ADDENDUM # 1

BID NO. : 2324
OPENING: 3/22/13 - 3:00 PM
COMMODITY: Dorr/Ellery Bathroom & Door Replacement

ADDENDUM NO. 1 – March 4, 2013

This Addendum forms part of the Contract Documents and modifies the Bidding Documents dated December 20, 2012, with amendments and additions noted below, for Roger Williams Complex Bathroom and Door and Signage Replacement – Dorr and Ellery Halls, University of Rhode Island, Kingston Campus, Kingston, RI..

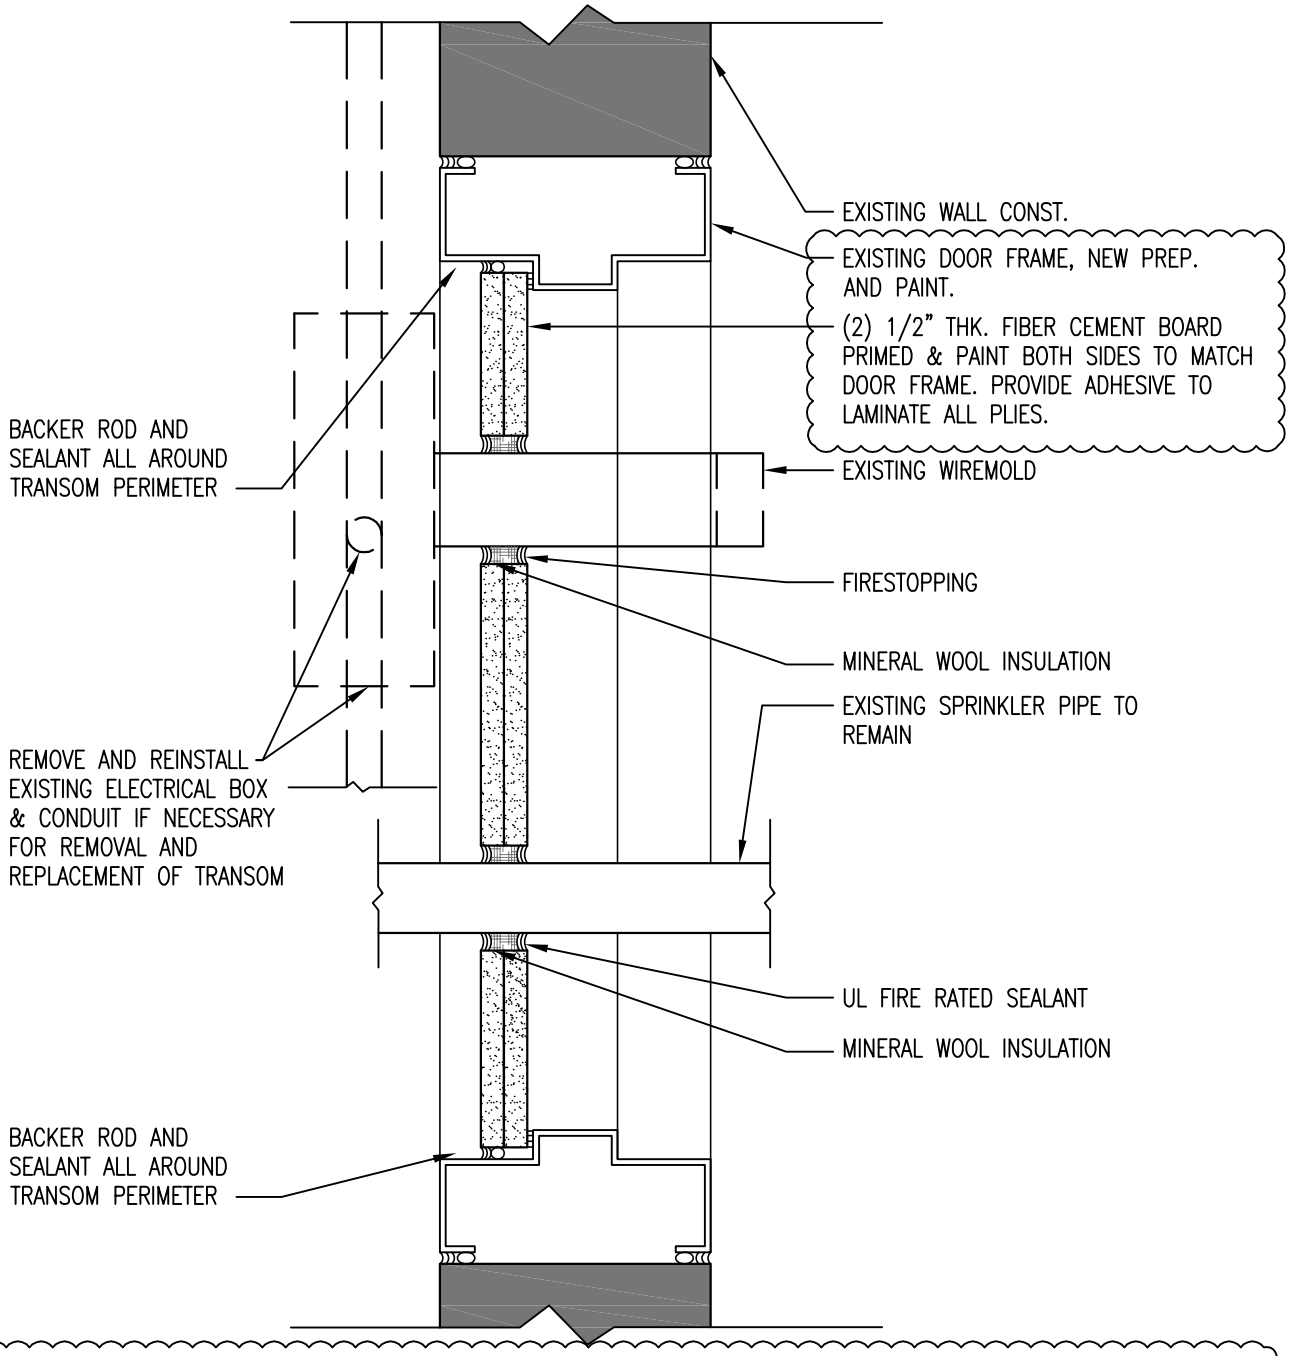
6. A8.101
Replace "Transom Horizontal Section" with attached SKA-1. Replace "Transom Vertical Section" with attached SKA-2.

UNIVERISTY OF RHODE ISLAND – ROGER WILLIAMS COMPLEX BATHROOM RENOVATION & DOOR & SIGNAGE REPLACEMENT
TRANSOM HORIZONTAL SECTION, DRAWING REFERENCE:
ALDRICH HALL: DETAIL F5, DRAWING A8.101
BURNSIDE HALL: DETAIL E5, DRAWING A8.102
CODDINGTON HALL: DETAIL E5, DRAWING A8.102
DORR HALL: DETAIL E5, A8.102
ELLERY HALL: DETAIL F5, DRAWING A8.101
HOPKINS HALL: DETAIL F5, DRAWING A8.101
